ADDENDUM NO: 1

PROJECT: **SITE IMPROVEMENTS AT FRANKLIN CENTRAL JUNIOR HIGH**

CONTEXT PROJECT NO: 22-1613 DATE: 2/13/2024 BY: Fred Prazeau

SCALE: 1"=30'

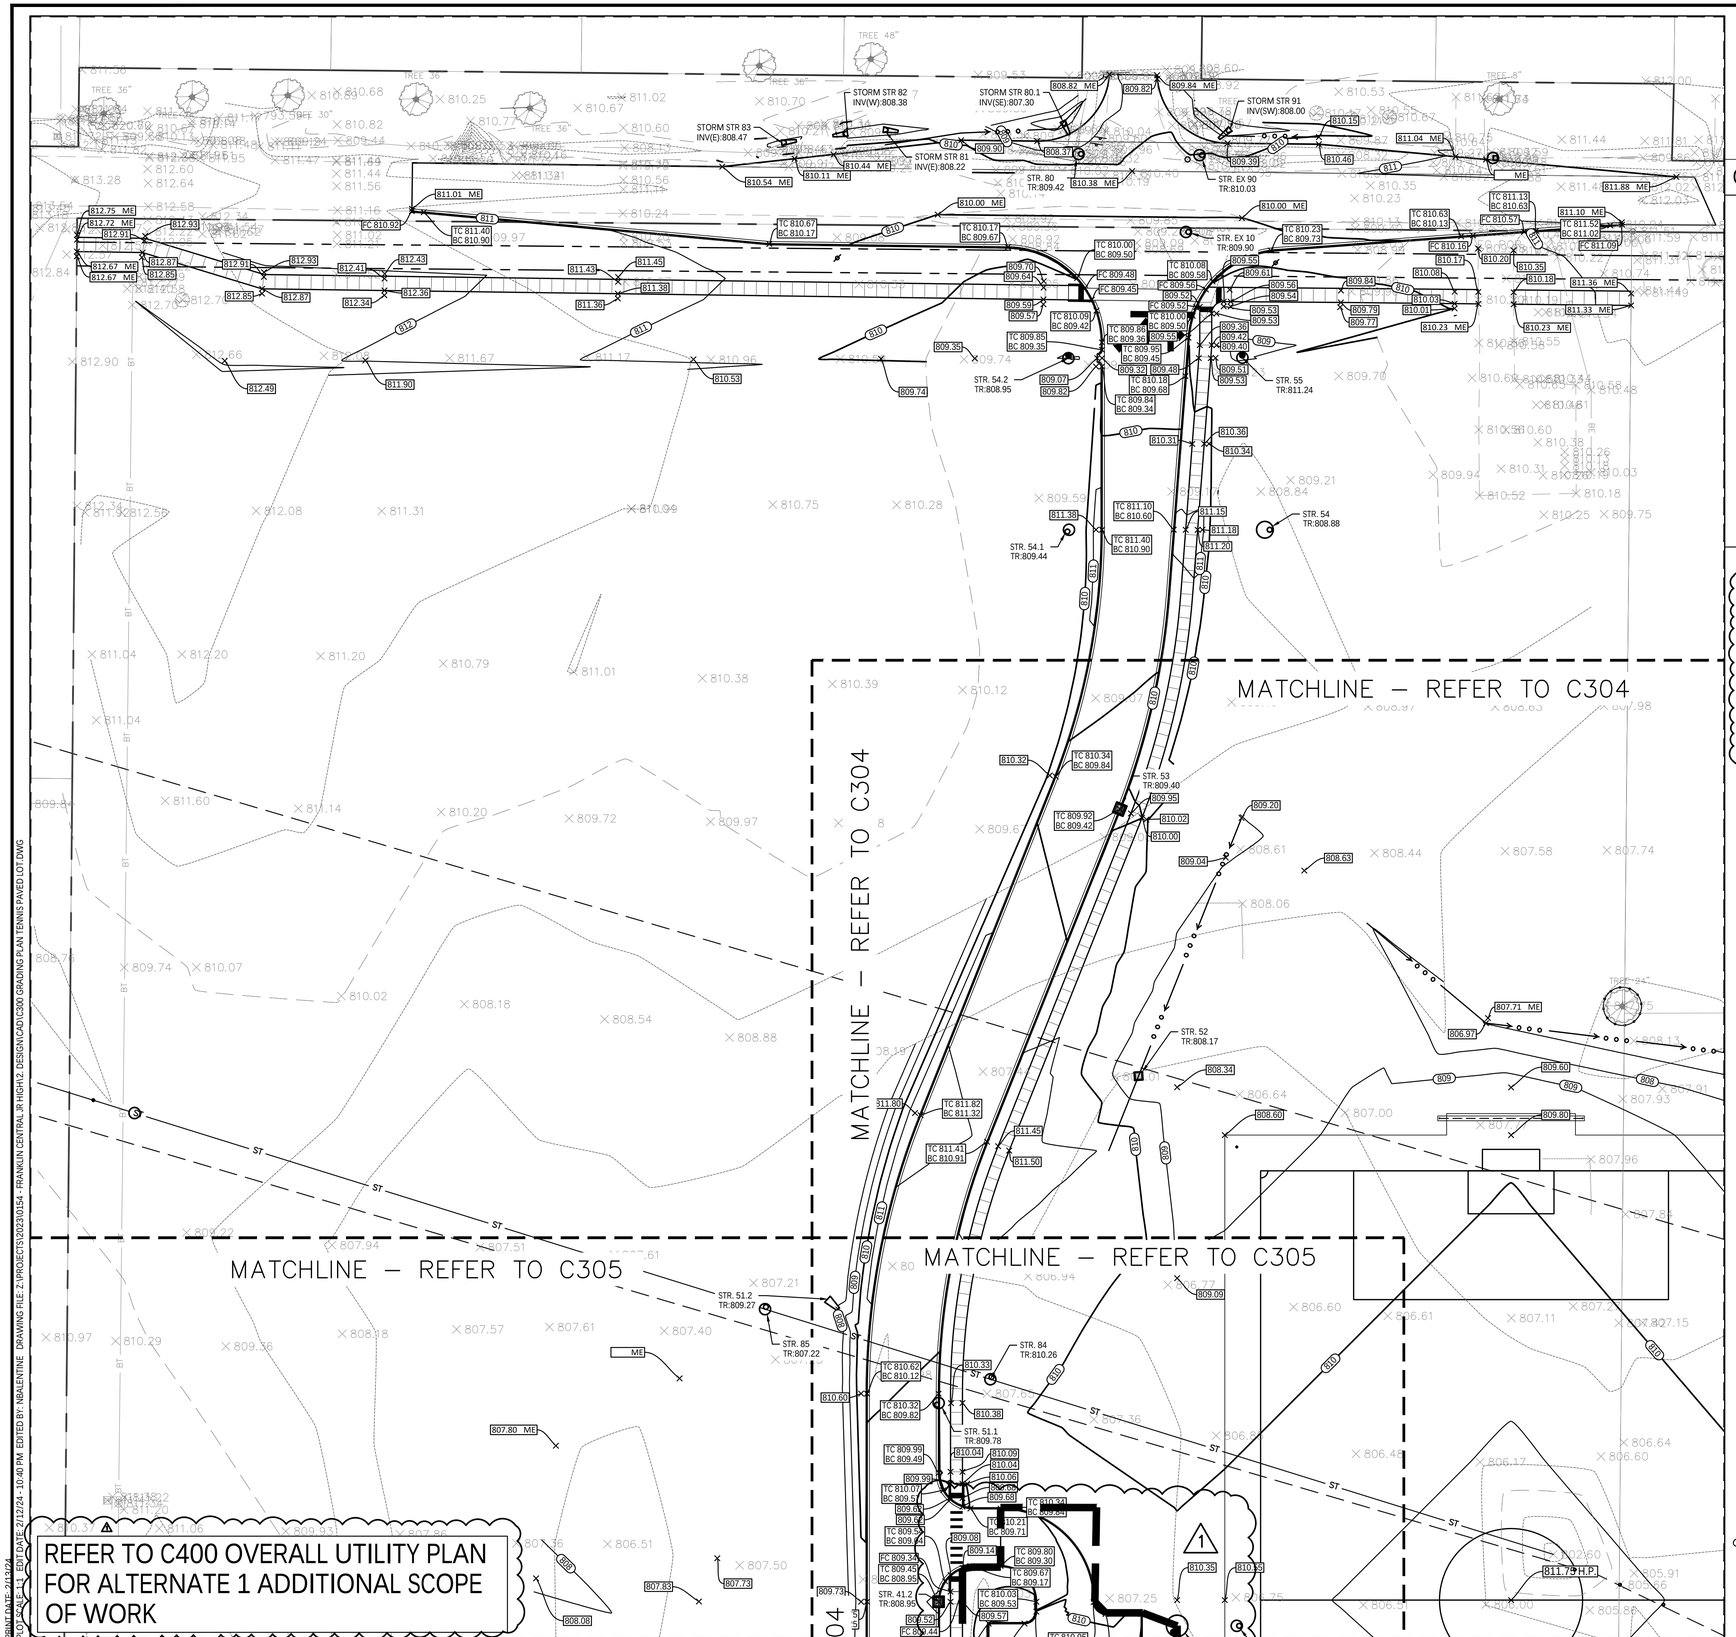
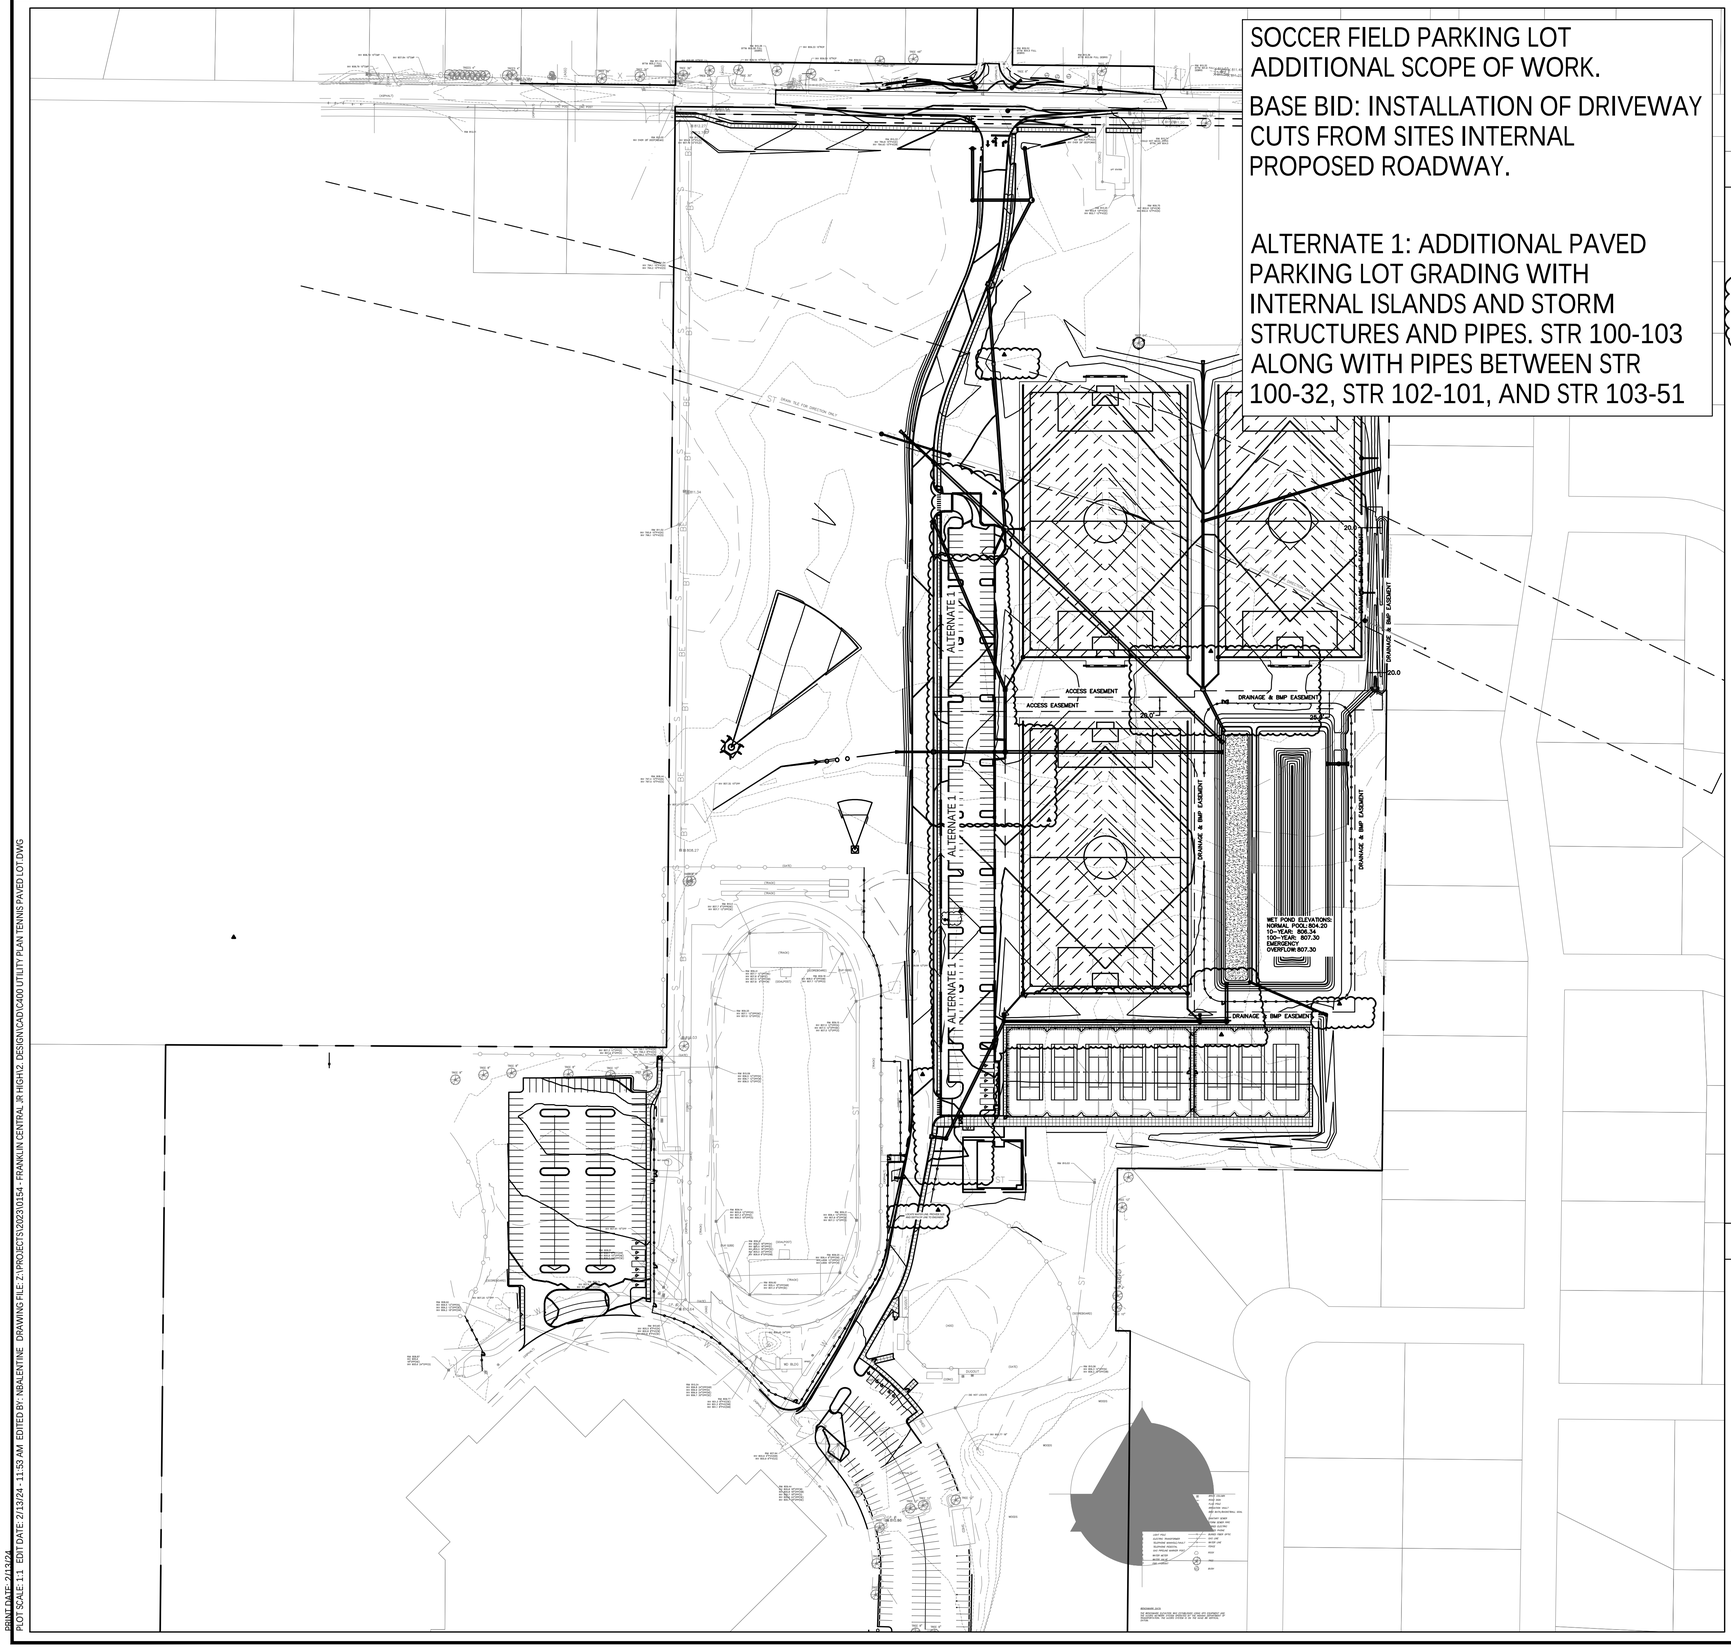
2. C300-Series Grading Plans reissued to address City comments, including clarification along drainage swales and grading in the vicinity of Alternate #1 – Soccer Parking.
